BENT GRASS EAST COMMERCIAL FILING 3

PRELIMINARY PLAN

8090 MERIDIAN PARK DR
EL PASO COUNTY, CO

PCD#: SP-20-010

LANDSCAPE NOTES AND DETAILS

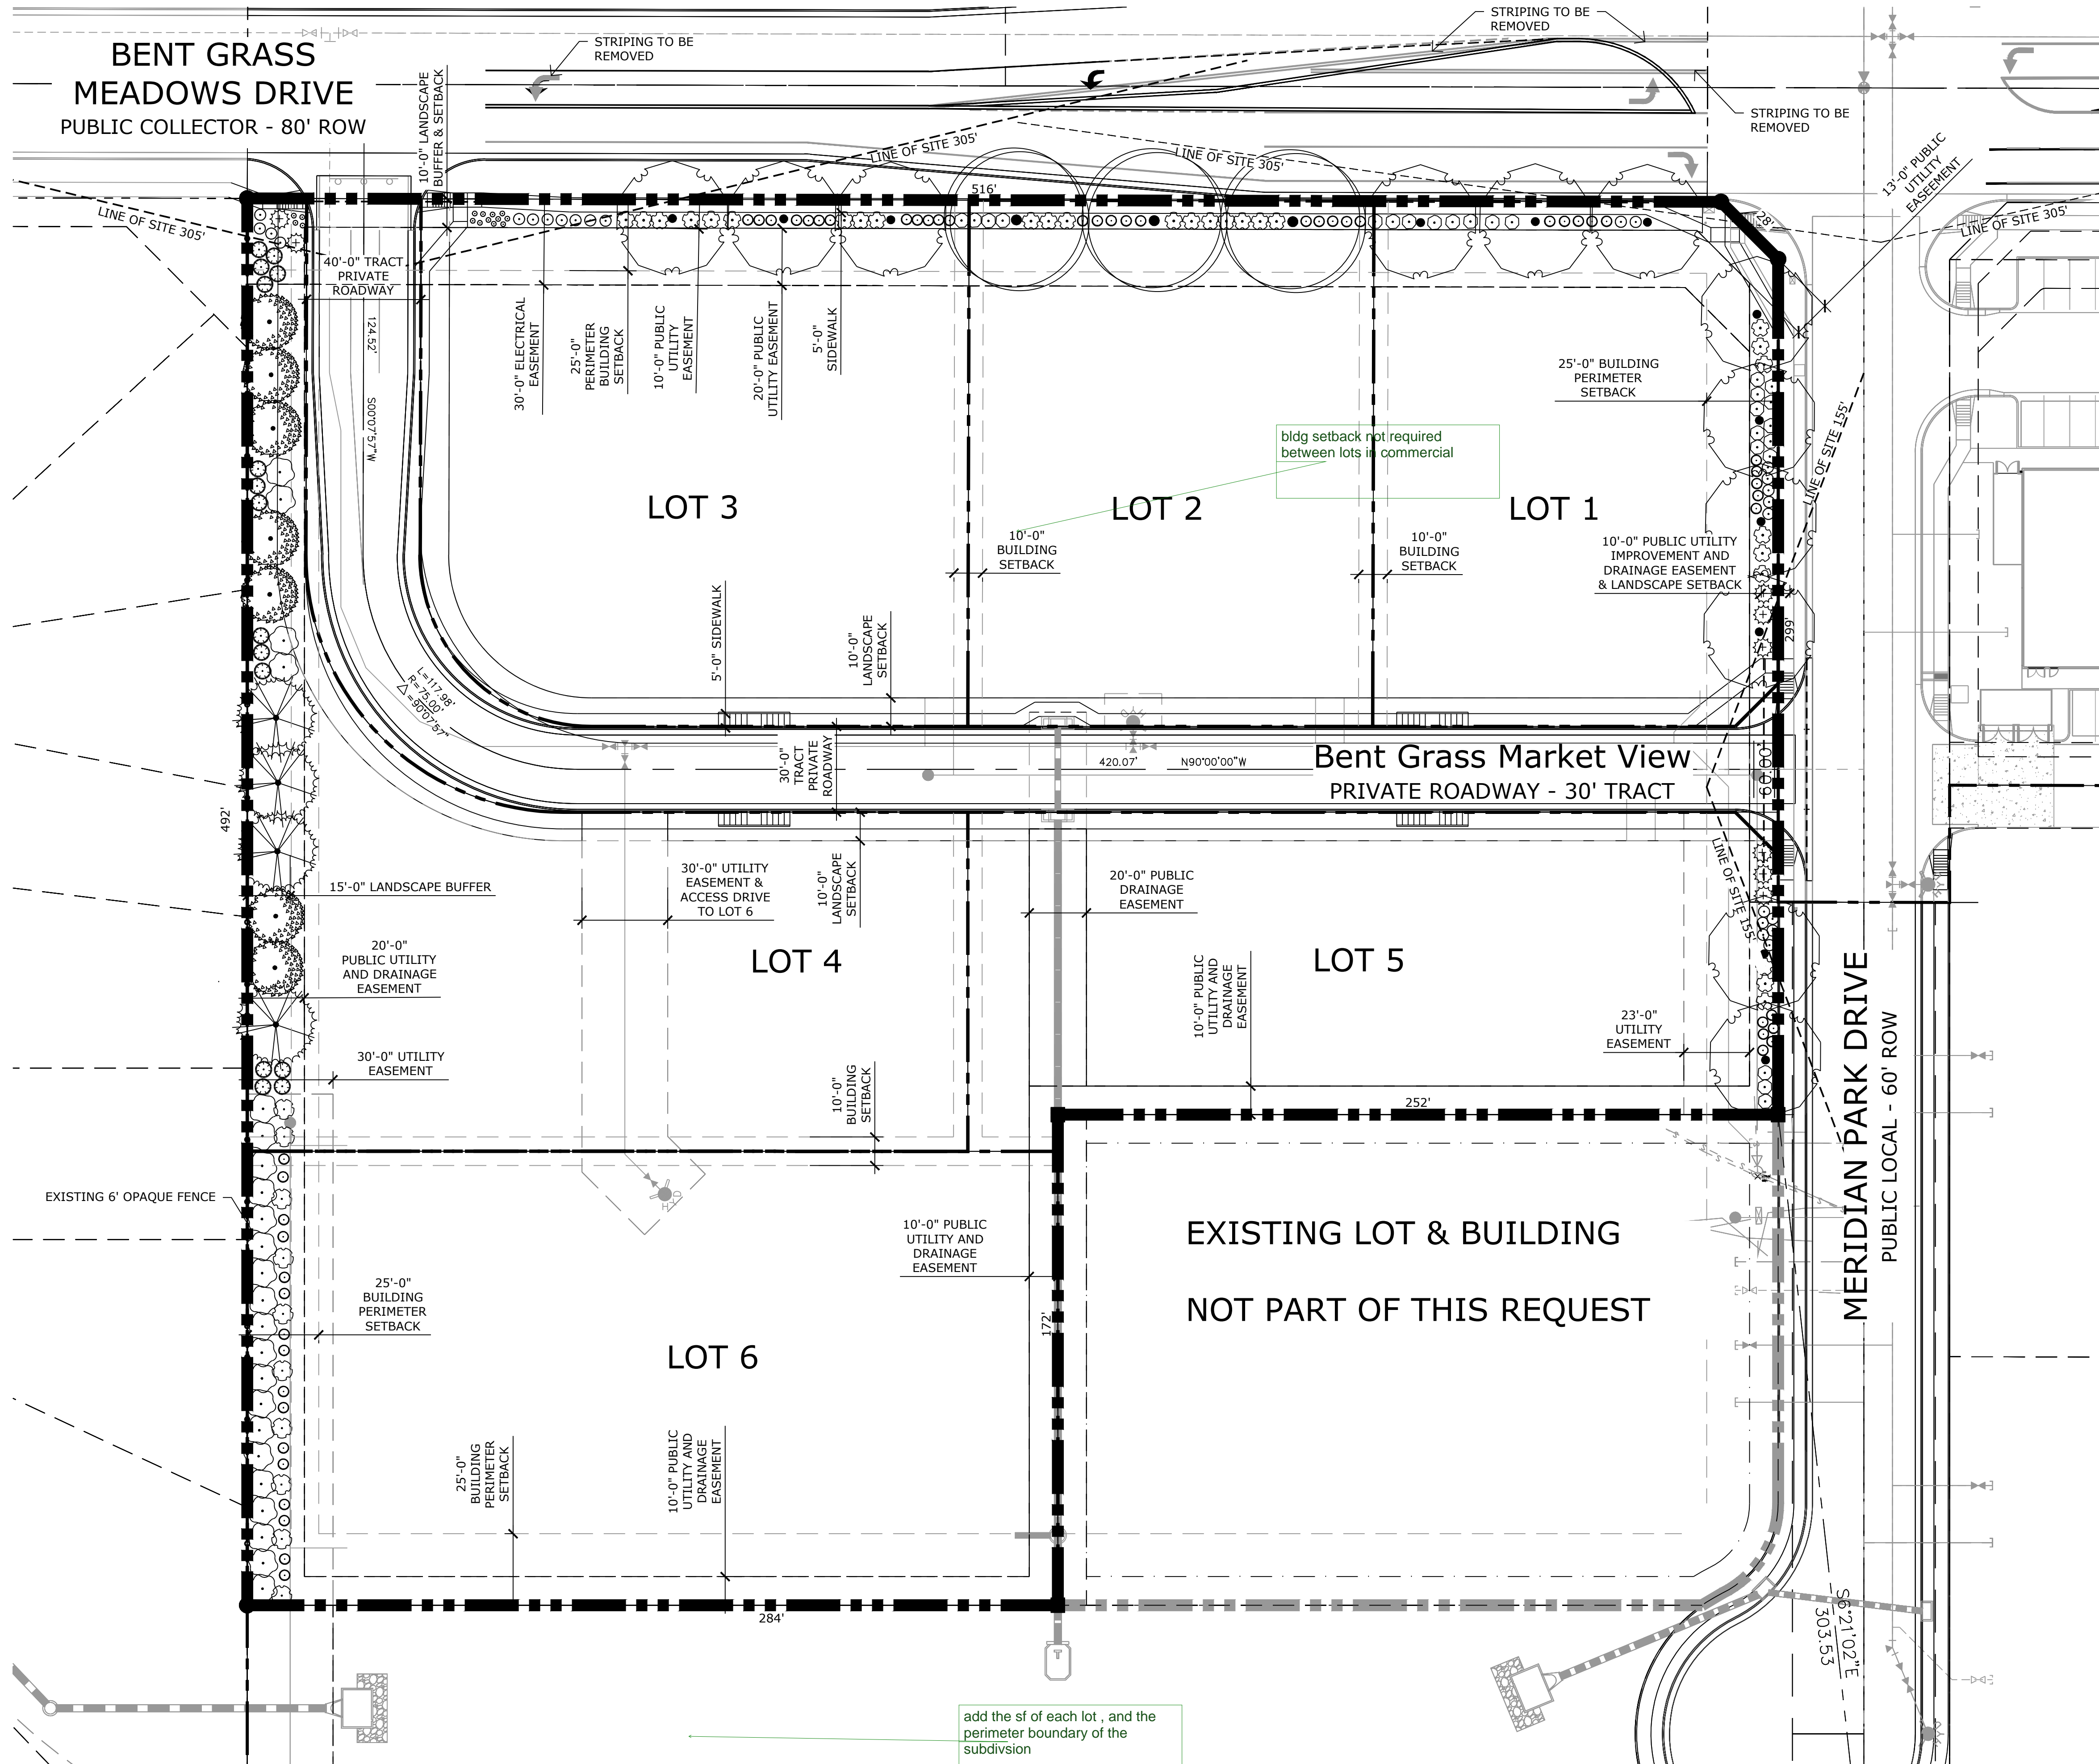
EVERGREEN TREE REQUIRED / Please show calculations for required for roadway and buffer

the commercial is responsible for the wall not the residential. Have you obtained a letter from the individual property owners that they agree to maintain the existing fence not wall on? Do they support a waiver of the opaque wall being installed and maintained by individual lot owners not commercial to support the waiver of the requirement for the commercial to provide the wall?

provide the commercial wall as required.

there is no requirement for the lot owners to have a fence; it is on the commercial. Maybe the commercial would like provide a maintenance agreement for fencing or replace the fence w concrete or CMU block? Staff will likely note the issue in the staff report
